Lincoln Middle Subdivision

City of El Paso — City Plan Commission — 2/8/2018

SUSU18-00004 — Major Combination

SUMMARY OF RECOMMENDATION: Planning staff recommends **Approval** of Lincoln Middle Subdivision on a major combination basis, however, does not recommend approval of the exception request.

Lindbergh Avenue - Section C

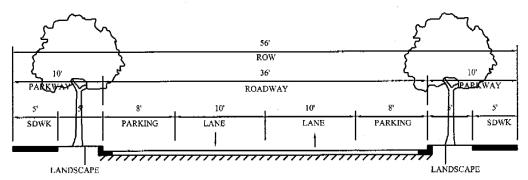
- To waive the required improvements to their proportionate share of Lindbergh Avenue, Mulberry Avenue, and Warriors Drive.
 - 1) Lindbergh Avenue Section C

The roadway requires 18' of participation – 16.5' is what exists. The parkway is in the wrong configuration.

<u>Lindbergh Avenue – Section D</u>

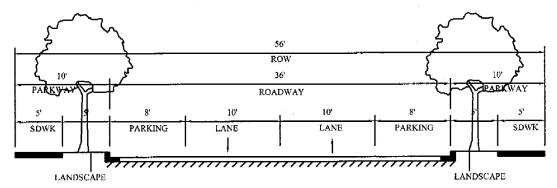
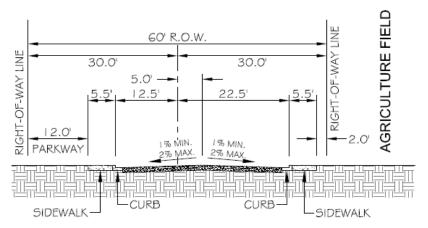
- 2) Lindbergh Avenue Section D
 - The parkway is in the wrong configuration.
- 3) Mulberry Avenue

Mulberry Avenue

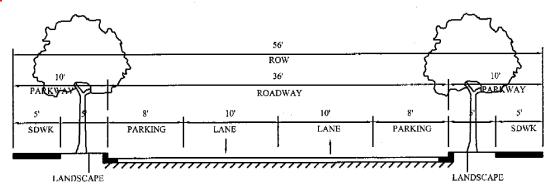
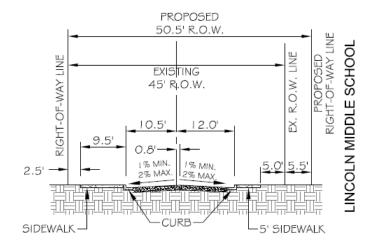
The roadway requires 18' of participation – 12' is what exists. The parkway is in the wrong configuration.

<u>Warriors Drive – Section F</u>

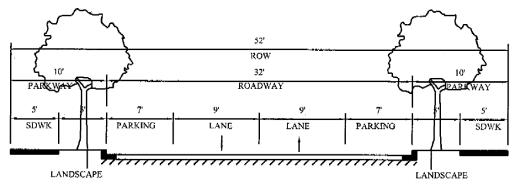
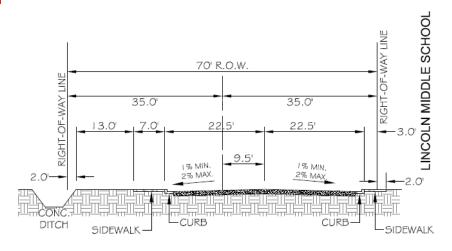
- 4) Warriors Drive Section F
 - Only 3' of parkway exists.
- To waive 2 feet of sidewalk along a portion of Warriors Drive (Warriors Section F)
 - 1) There is only 3 feet of sidewalk within the ROW and the DSC requires 5 feet. The remaining 2 feet is within private property.
